Project	IEEE 802.16 Broadband Wireless Access Working Group < http://ieee802.org/16 >	
Title	Space-frequency bit-interleaved coded modulation for MIMO-OFDM/OFDMA systems	
Date Submitted	2005-01-25	
Source(s)	Sumeet Sandhu, Nageen Himayat, Shilpa Talwar, David Cheung, Qinghua Li, Yuval Lomnitz, Wendy Wong, Uri Perlmutter, Yang-seok Choi, Eddie Lin Intel Corporation	sumeet.sandhu@intel.com Voice: +1-408-765-8558
Re:		
Abstract	<p>Draft 802.16e/D5a contains references references to horizontal and vertical encoding architectures <u>as means to map spatially multiplexed schemes to multiple antennas. However, the exact details of the mapping are not specified. Interleaving of spatial streams across antennas is important to achieve spatial diversity for MIMO systems.</u> for MIMO. Starting on page 362, the vertical encoder proposed for spatially-multiplexed MIMO systems does not specify details of the blocks shown in Figure 251c, i.e. the Encoder, Modulation, Demux and Sub-carrier mapping/PRBS blocks. It is important to design these blocks carefully to fully exploit spatial and frequency diversity with all types of receivers.</p> <p>In this contribution we propose space-frequency bit-inte

Figure 1: Space-frequency bit-interleaved coded modulation (SF-BICM)

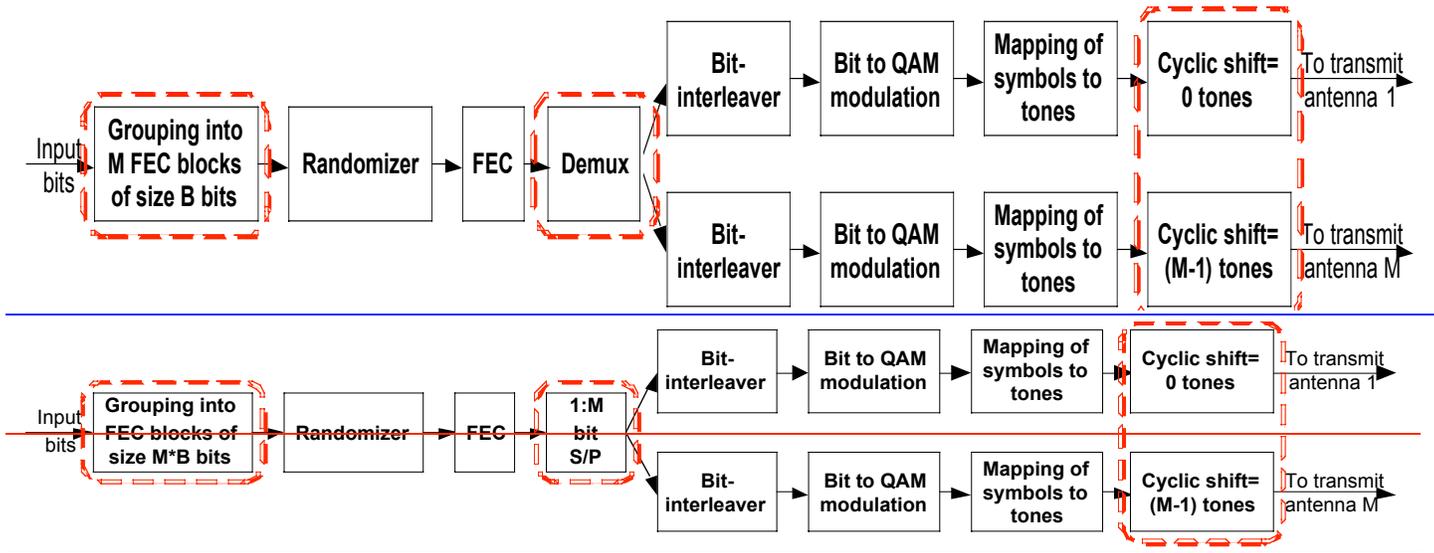
[This section describes 4 steps for mapping bits to multiple spatial streams and tones. The key changes are steps 1, 2 and 4, and are circled in red in the figure below.](#)

- 1) **FEC encoding:** The incoming uncoded bits are grouped into M blocks of size MB and encoded with the usual convolutional code and punctured. The coded output blocks are of size MN_{CBPS} .

- 2) **Serial to parallel multiplexing (Demux):** The demultiplexer extracts bits for the chains one by one from its input bit sequence. The bits to the chain with higher modulation order are extracted before those with lower modulation order. Denote the number of bits per subcarrier on the m -th chain as L_m , where $L_1 \geq L_2 \geq \dots \geq L_M$. The demultiplexer first extracts the bits for the chain with the greatest modulation order as follows. The i -th extracted

bit is the k -th bit in the original input bit sequence, where $k = \text{round}\left(\frac{i}{L_1} \sum_{m=1}^M L_m\right)$. For the p -th chain, the i -th extracted bit is the k -th bit in the remaining bits after the extractions for the previous $p-1$ chains, where

$k = \text{round}\left(\frac{i}{L_p} \sum_{m=p}^M L_m\right)$. ~~The FEC block is multiplexed to different spatial streams. The bits indexed by~~

~~$m: M: MN_{CBPS}$ are mapped to the m^{th} spatial stream for $m=1, \dots, M$.~~

- 3) **802.16e interleaving and tone mapping:** The resulting groups of N_{CBPS} bits on each spatial stream are interleaved according to the 802.16e interleaver and Gray mapped to QAM symbols. The resulting QAM symbols are mapped to N_{DS} tones according to 802.16e sub-channelization and tone-mapping. The same set of tones is occupied on each spatial stream.
- 4) **Cyclic tone shift:** The final step consists of cyclically shifting the symbol sequence mapped to the m^{th} spatial stream by $m-1$ tones to the right.

Figure 3: Proposed SF-BICM mapping of bits to multiple antennas (or spatial streams)

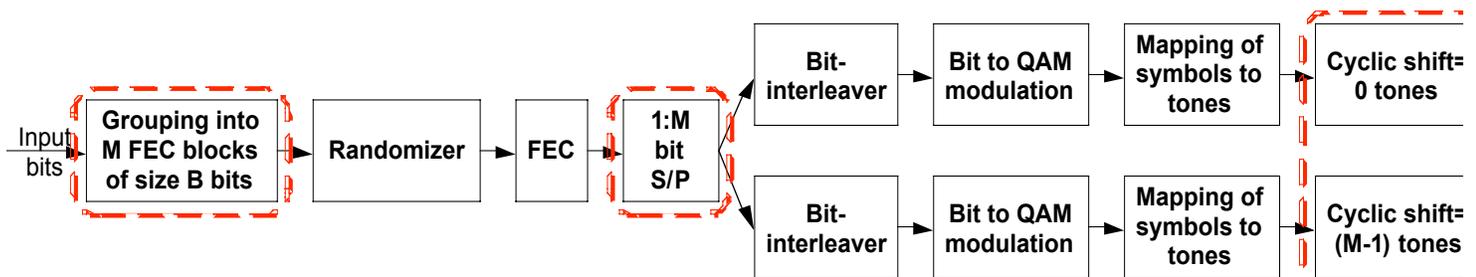
The proposed modifications to the existing 802.16e bit-to-tone mapping are steps 1, 2 and 4 as circled in red below.

- 1) **FEC encoding:** Group the incoming uncoded bits into M blocks of size MB , such that the coded output blocks are of size MN_{CBPS} . It is important to create larger FEC blocks to preserve frequency diversity going from SISO to MIMO systems. If the FEC block size were held constant and N_{CBPS} bits were mapped to $1/M$ of the SISO tones on M antennas, spreading across fewer tones on each antenna will not provide full frequency diversity. However, we choose to restrict our block sizes to B bits in order to maintain compatibility with the existing standard.
- 2) **Serial to parallel antenna multiplexing:** Coded bits are serial to parallel multiplexed to different antennas. The bits indexed by $m:M:N_{CBPS}$ are mapped to the m^{th} antenna.
